# Field Bulletin

- Harness Keying Issue
- SC6602 ONLY

<b>Bulletin #:</b>	<b>FG00804 Rev A</b>
<b>Bulletin Date:</b>	<b>November 10, 2004</b>
<b>Subject:</b>	<b>Interface Harness Key Plug</b>
<b>Affected Model(s):</b>	<b>SC6602 <u>Only</u></b>
<b>Updated Config. Code #:</b>	<b>N/A</b>

Figure 3

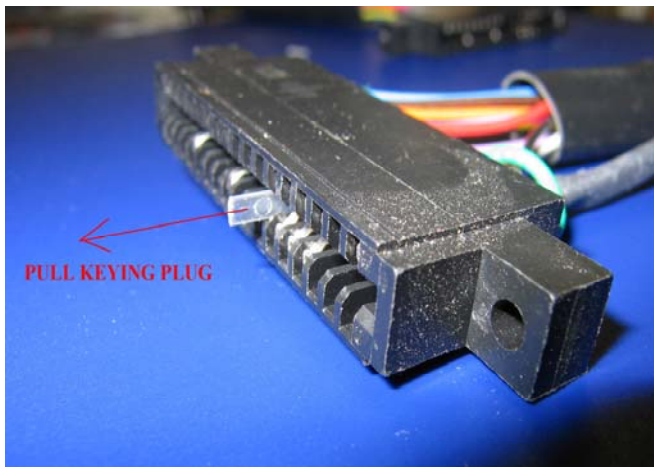
- Remove the plastic keying plug that's in the header preferably with a dental pick. (See Fig2&3) The keying plug that you will remove will be crushed to about ¼ the size of the plug in Fig.3 and will be pressed towards the rear of the header. The newer interface card that the interface harness mates onto doesn't have a cutout for the keyplug. (See Fig.4)

After identifying a harness in the field that has the keying plug, a rework procedure needs to be performed. The rework can be performed with the interface harness still mounted to the chassis, or with it removed from the chassis mounting points.

When replacing older (slotted) interface cards with newer (no slot) interface cards, verify that the key plug has been removed from the interface harness connector prior to installation.

Figure 4

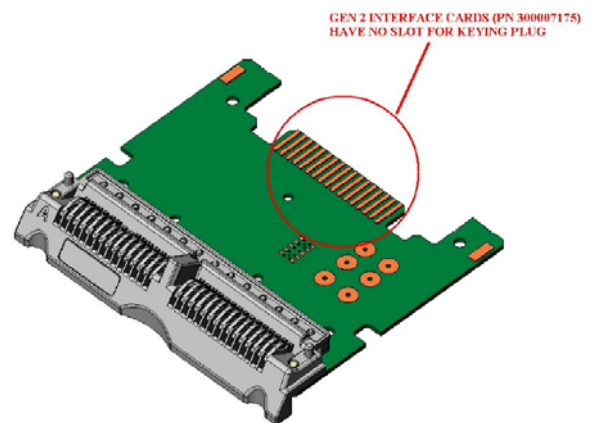
The Y8 revision Interface harness for the SC6602 that has the keying plug installed will not mate properly when used with a newer SC6602 interface card. Newer interface cards have the key slot removed.
